**MPC Paper No. 8/17
For Consideration by the
Metro Planning Committee on 27.10.2017**

**Submission for Partial Fulfillment of
Approval Condition (a) under Application No. A/H15/232-2**

**Proposed Hotels in “Other Specified Uses”
annotated “Ocean Park” Zone, Ocean Park**

Master Layout Plan of Current Updated Scheme

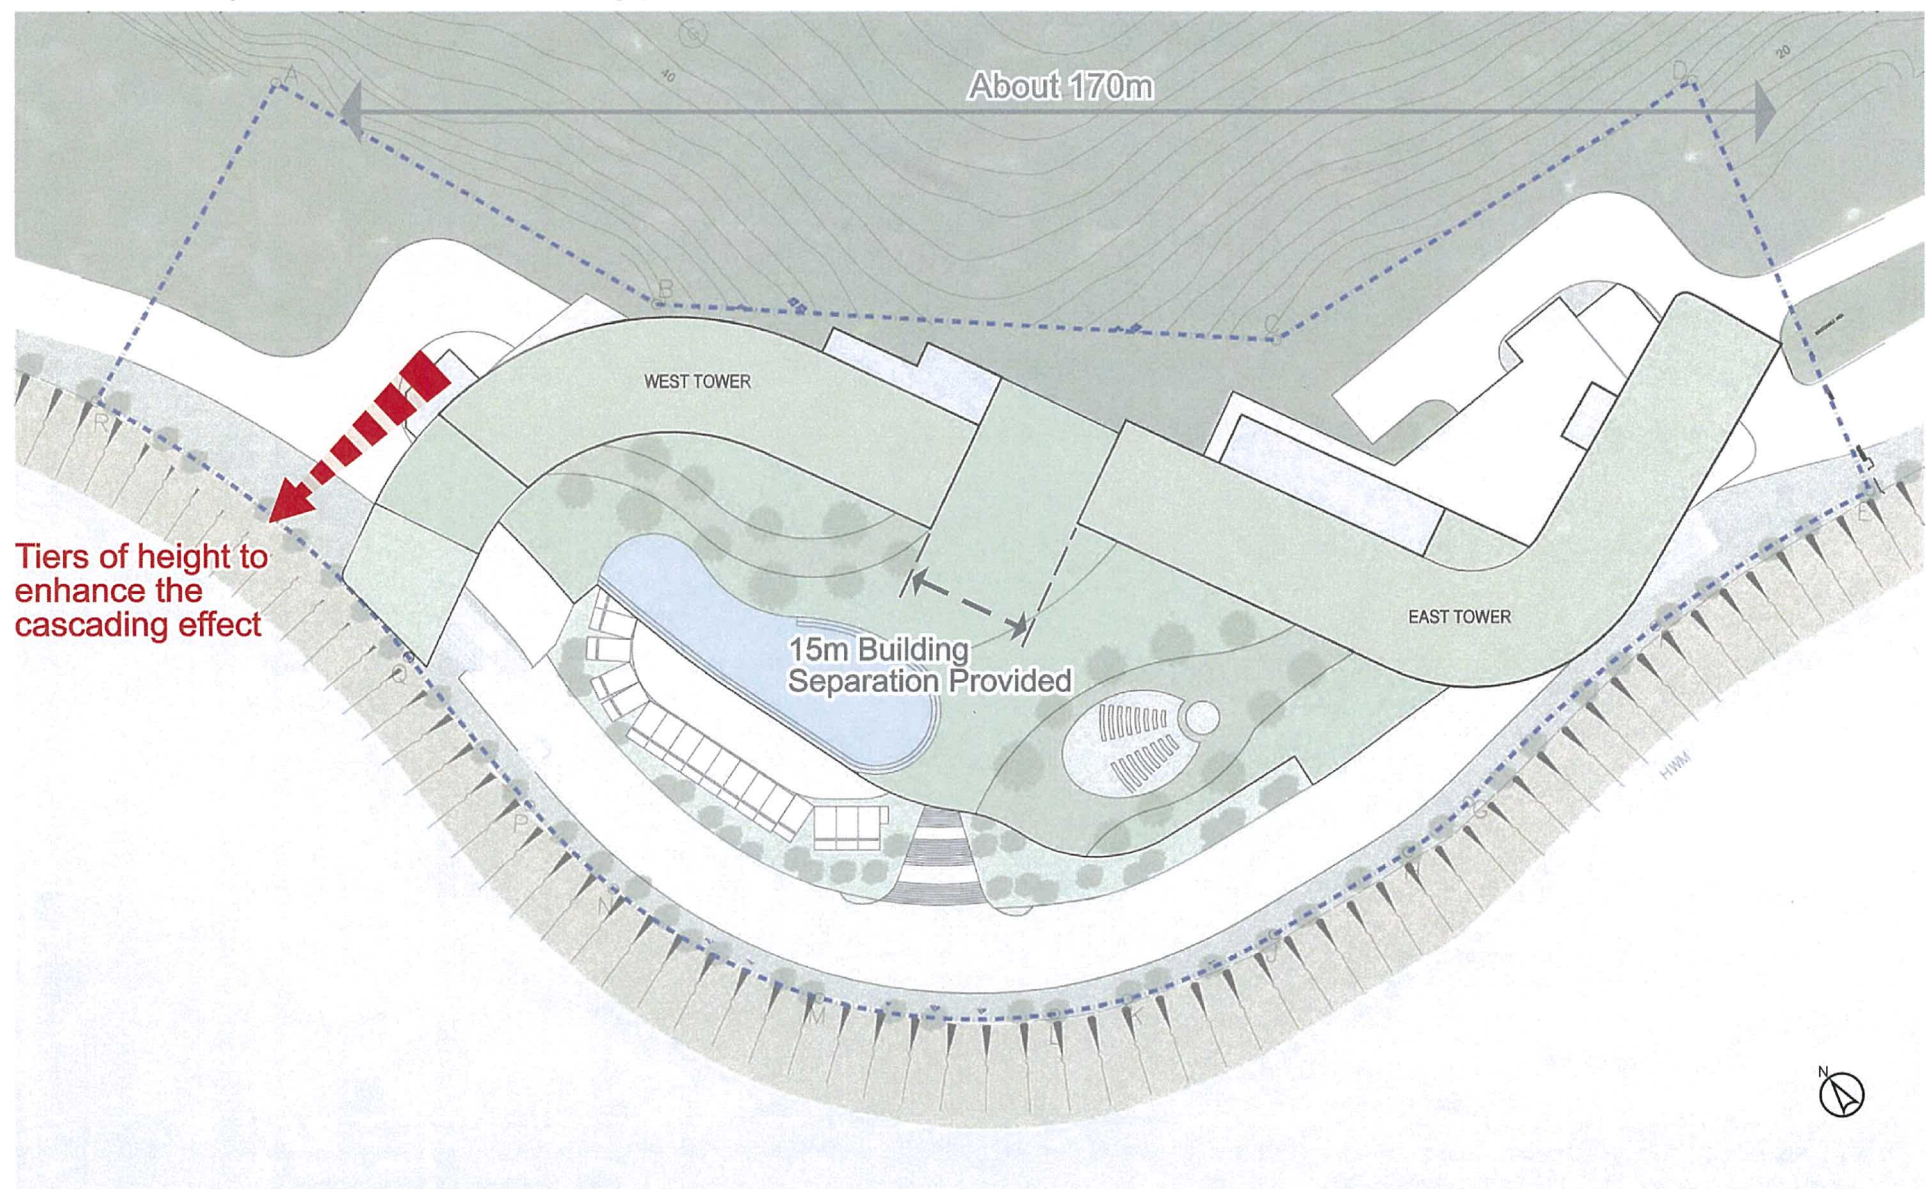
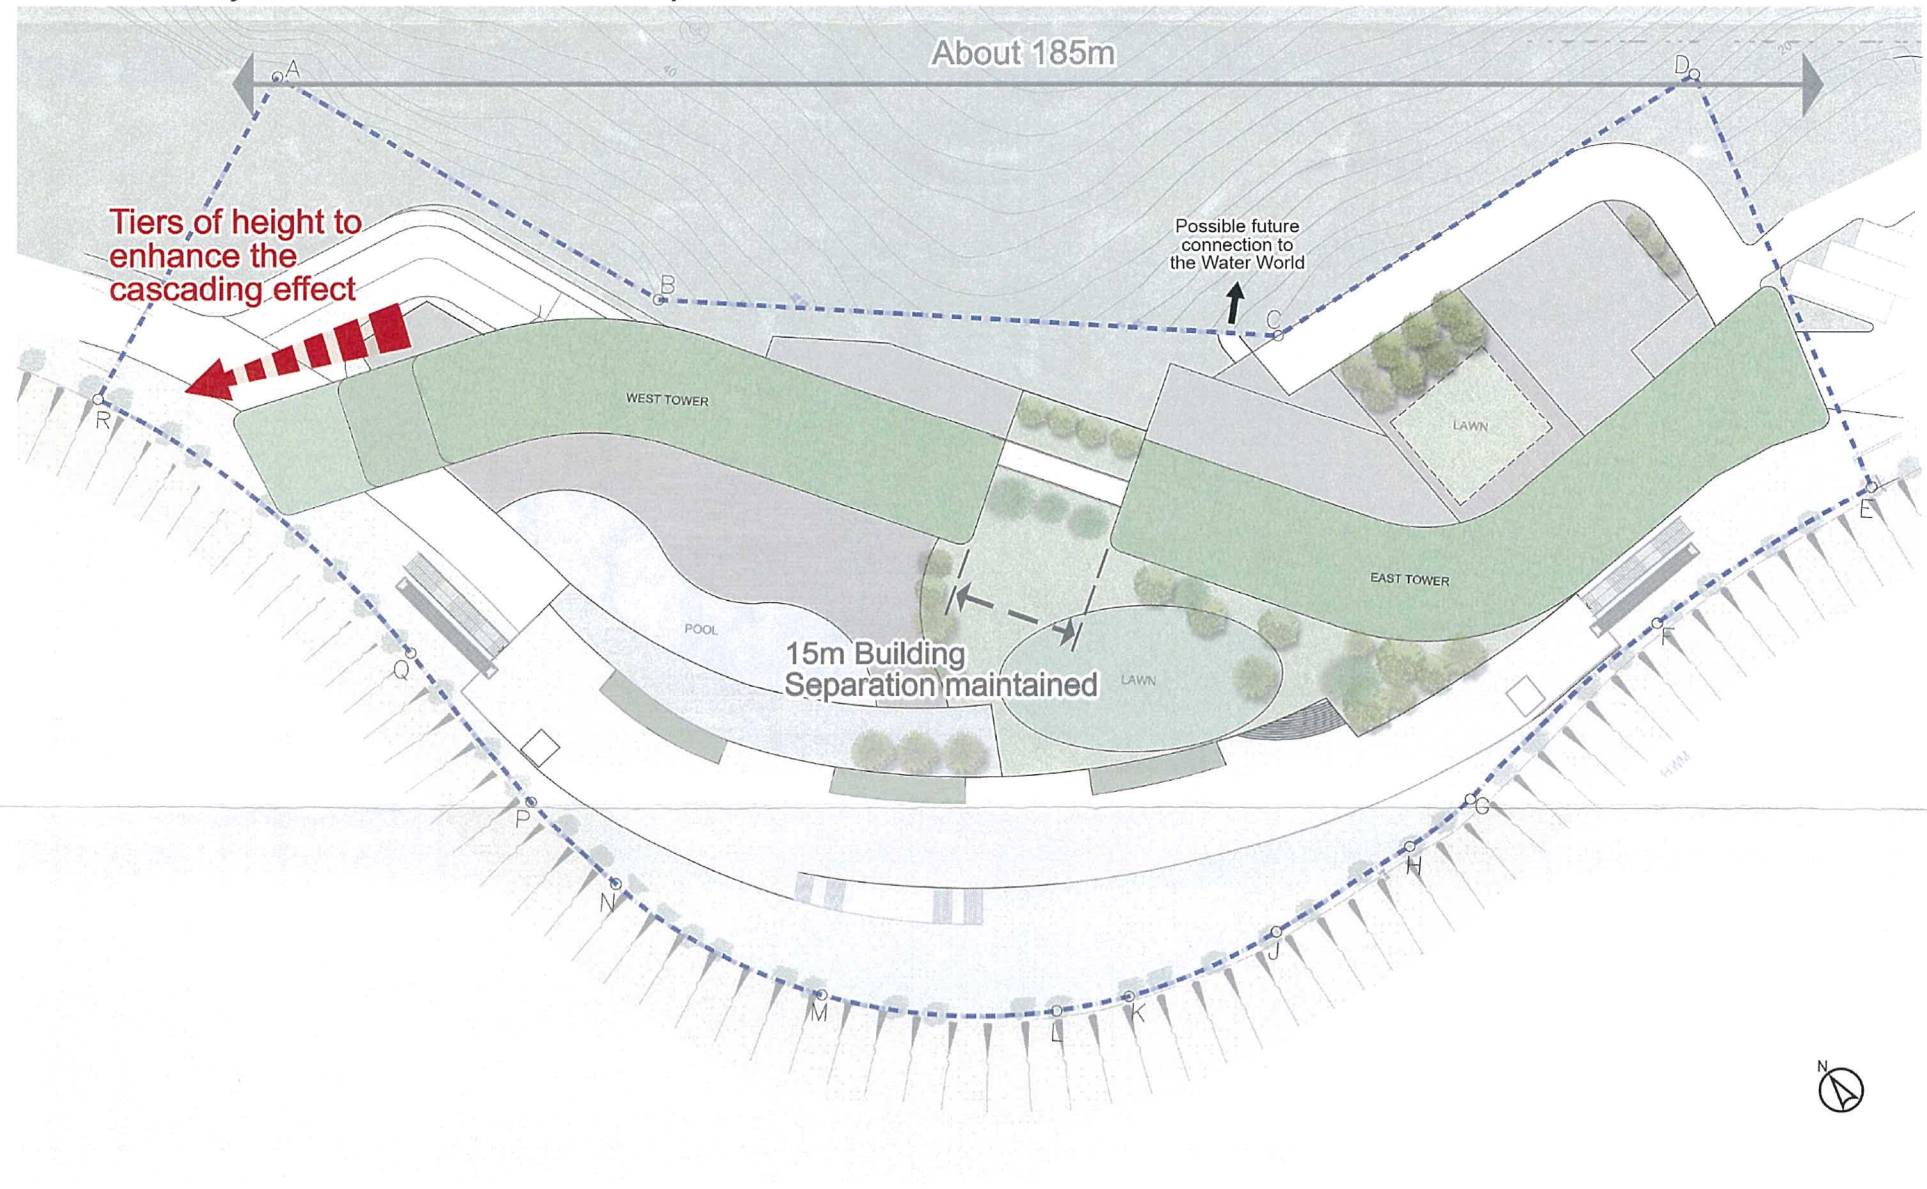
We would like to submit herewith the updated Figure 3.12a with minor clarifications of the annotations on the plan. No changes were made to the proposed layout of the Current Updated Scheme. The enclosed figure would serve to supersede the Figure 3.12a submitted to the Board previously on 29 August 2017.
